BURLINGTON DEVELOPMENT REVIEW BOARD

Tuesday, May 2, 2023, 5:00 PM

MEMORANDUM

RE: ZAP-23-3; 25 Oakledge

Submitted existing conditions site plan. Note multi-path driveway.

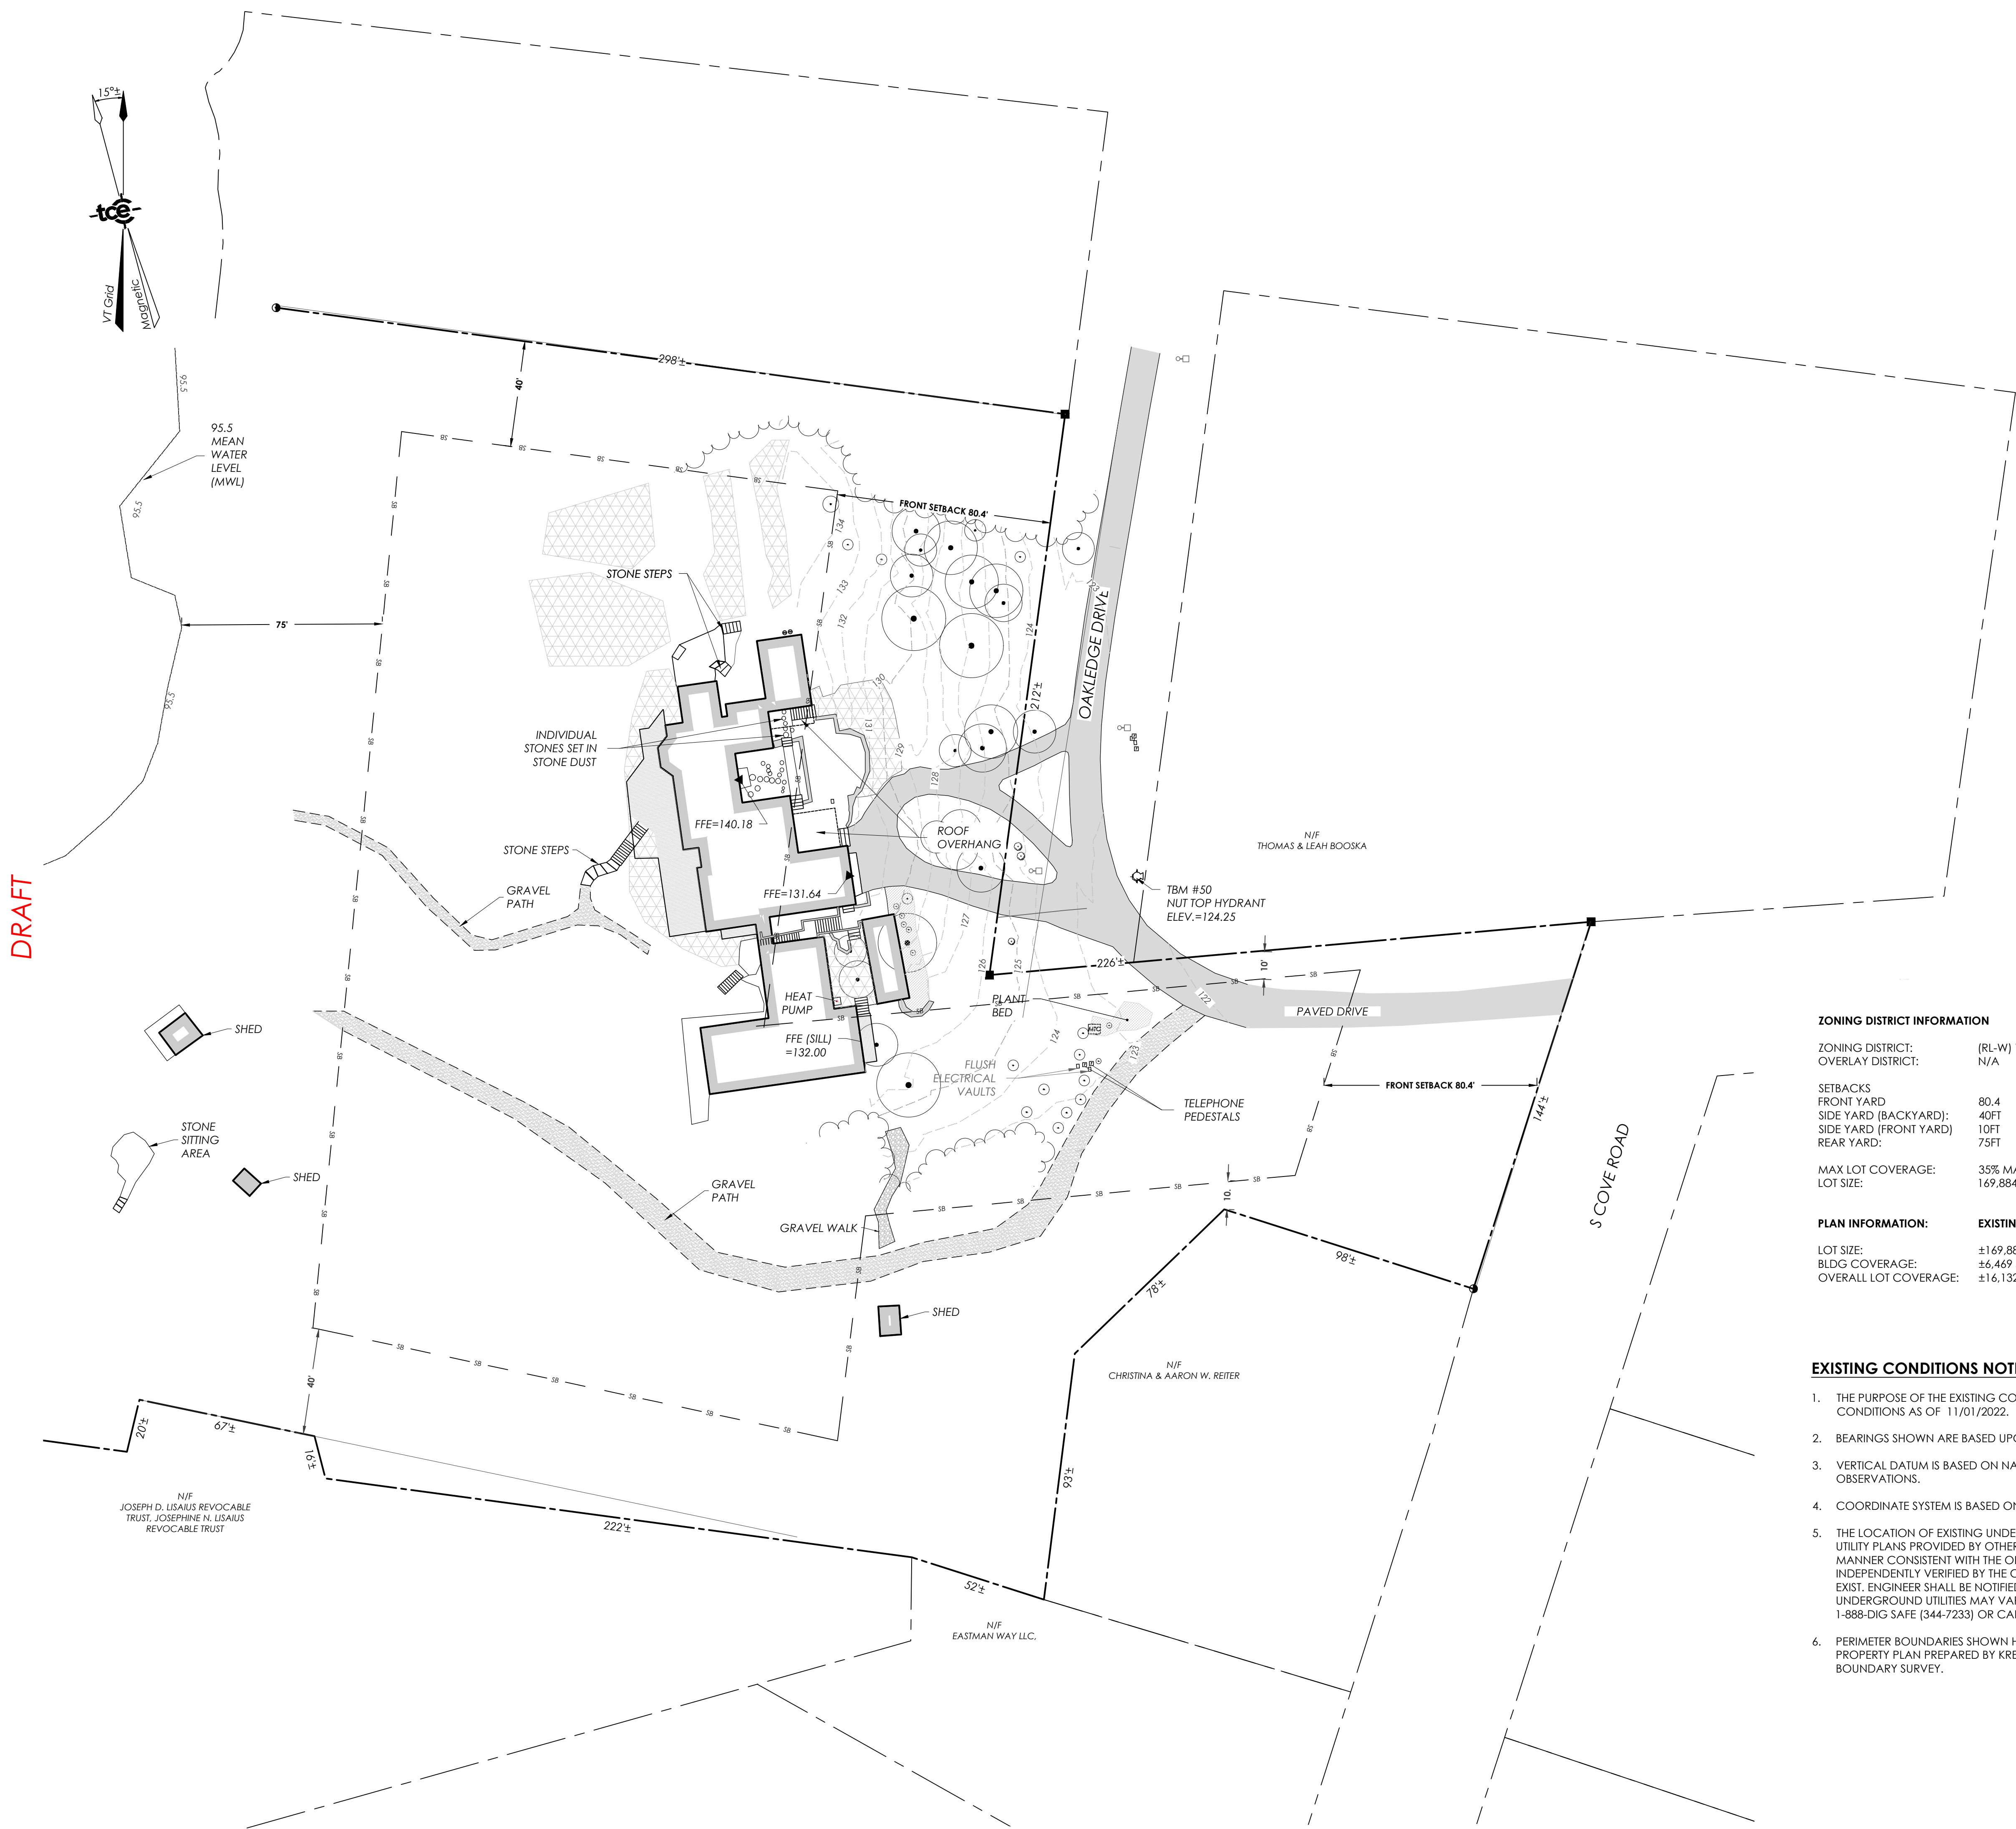
The driveway layout includes a parking area in front of the principal structure; in conflict with this standard. It is entirely possible to organize the new drive access without the front yard parking area, even if only by retaining the current southerly access lane. **Adverse finding.**

As proposed, the reconfigured driveway introduces parking space(s) within the Front Yard Setback (see illustration above), and in front of the residential structure; contradictory to the standard of Section 8.1.12 (b). **Adverse finding.**

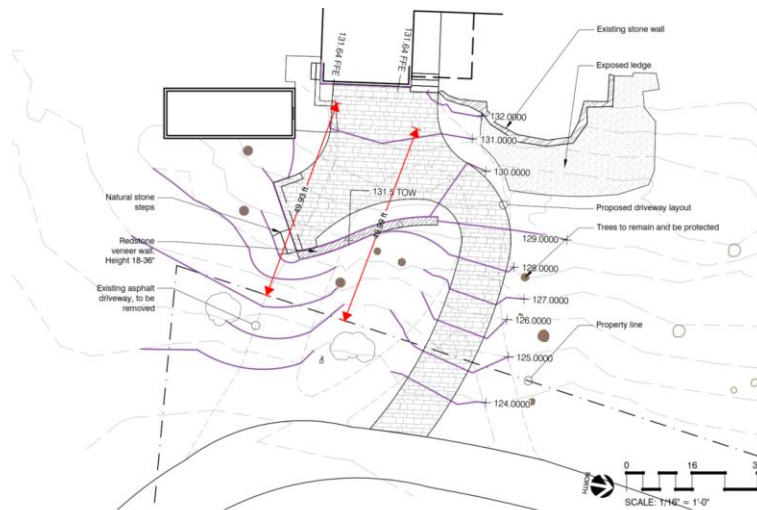
The calculated front yard setback of 50', based on the submitted driveway plan:

As proposed, the reconfigured driveway introduces parking space(s) within the Front Yard Setback (see illustration above), and in front of the residential structure; contradictory to the standard of Section 8.1.12 (b).

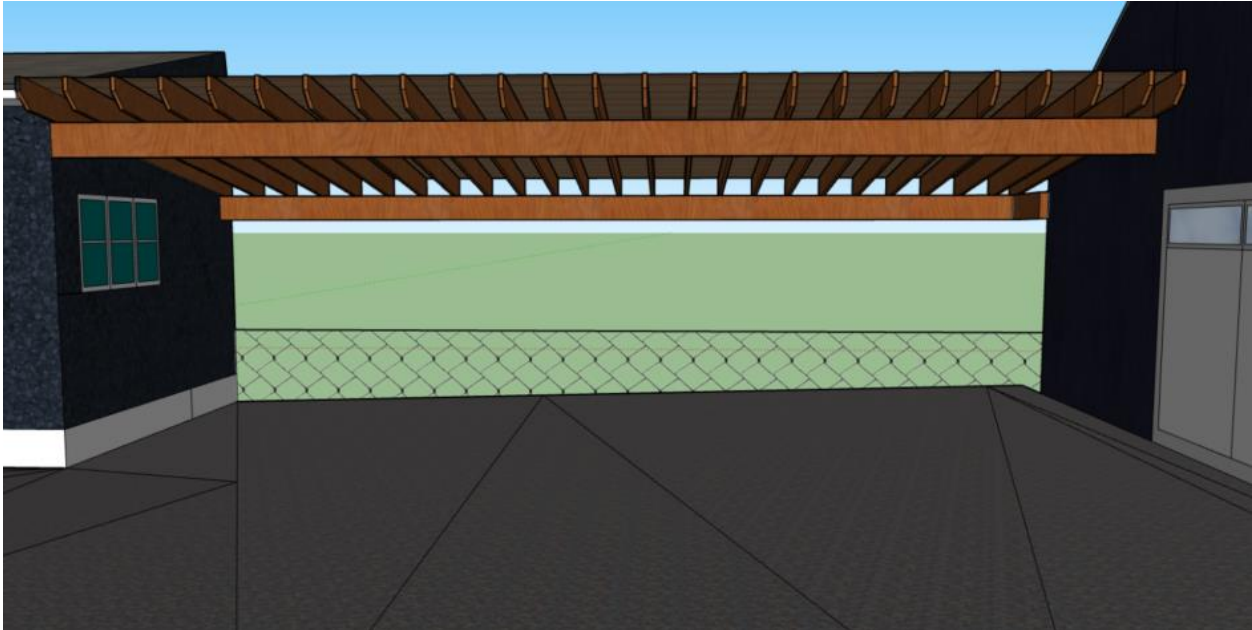
The proposed connector is a set of parallel roof joists, presenting rafter tails which extend into the required side yard setback. A minimum 2.7’ setback is required, 10% of the lot width at the point of the development. They are poised approximately 1.3’ from the side property line.

Rafter tails do not meet the definition of Eave (see below), and as a largely open structure, not a solid or boxed roof overhang.

Adverse finding for interpretation as Eave. The roof is not a solid plane, but the exposed and projecting rafter tails might be determined to be a “roof overhang.” This interpretation is at the discretion of the DRB.

Project	Sheet
Date 3/3/23	SP-2
Scale 1/16" = 1'

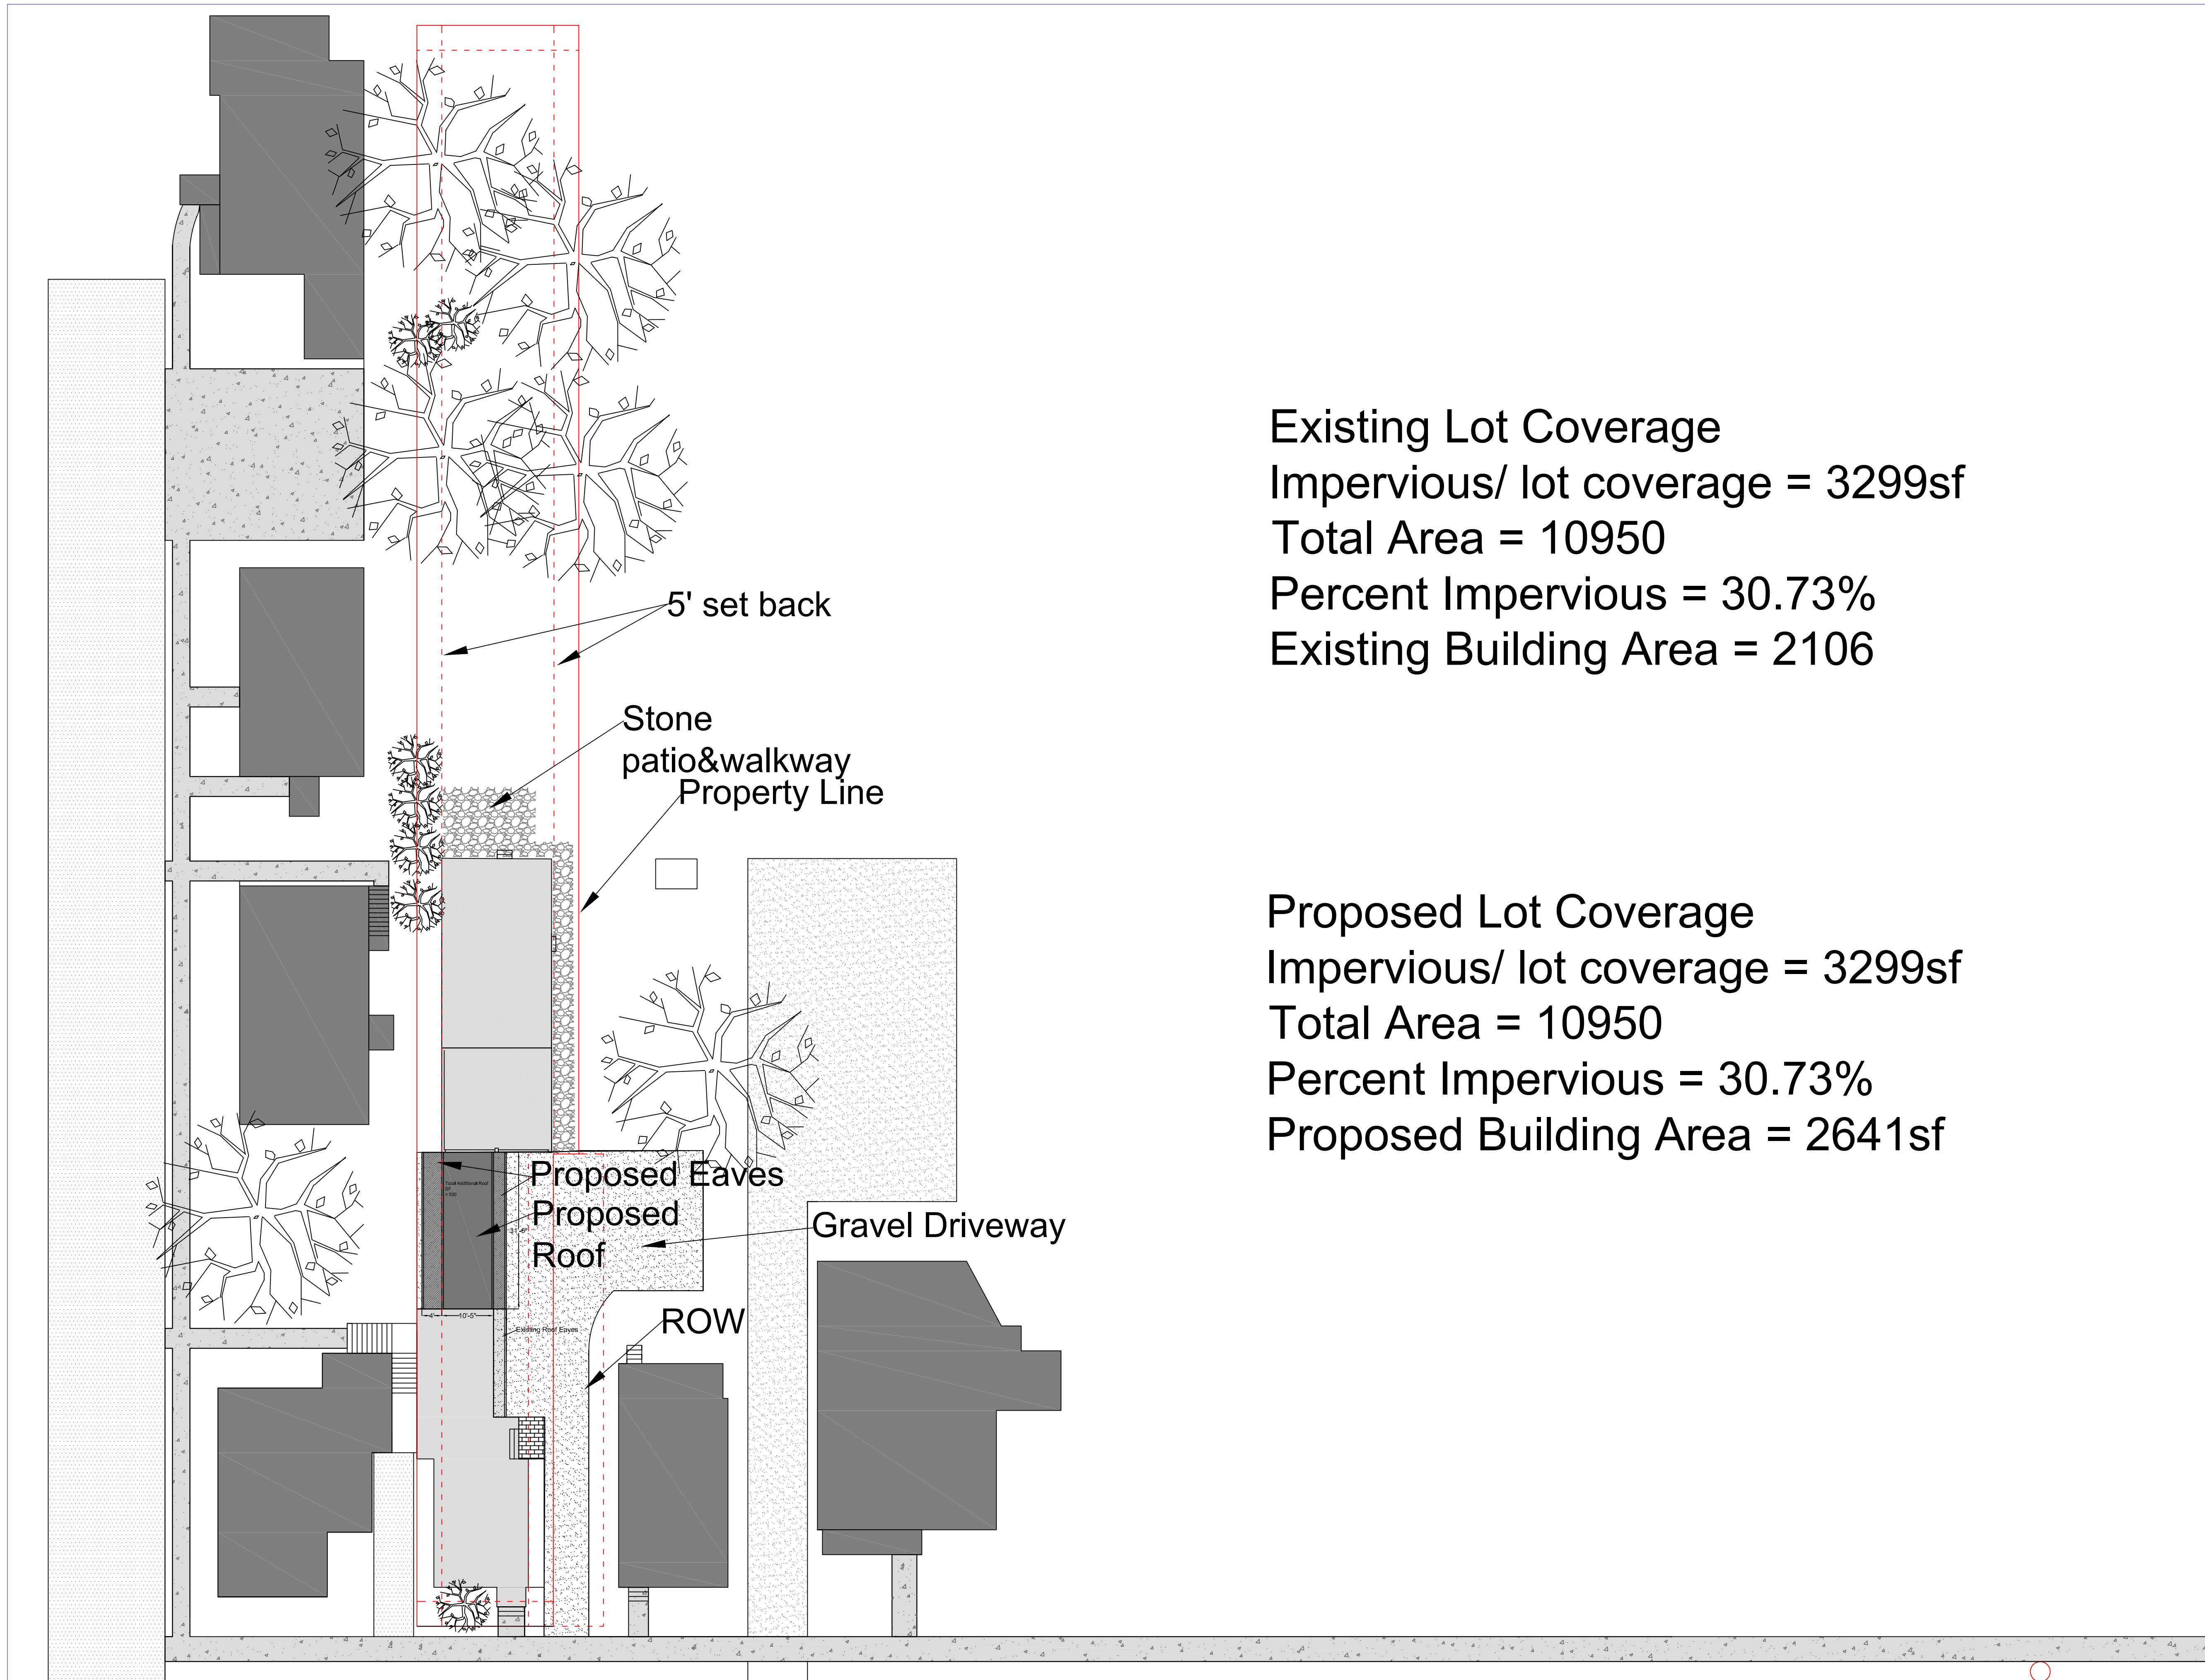
No change is proposed to the number or location of parking. The applicant has provided a revised site plan that suggests vehicles may back up onto the neighboring parcel (SP-2). The property deed is attached that provides for a 10’ easement 95’ in depth for the shared driveway. The allowance does not include utilization of the neighbor’s parking area, and this application will not consider utilization of another parcel.

No change to parking; however applicant may not utilize the neighbor’s parcel as suggested in the submitted plan.
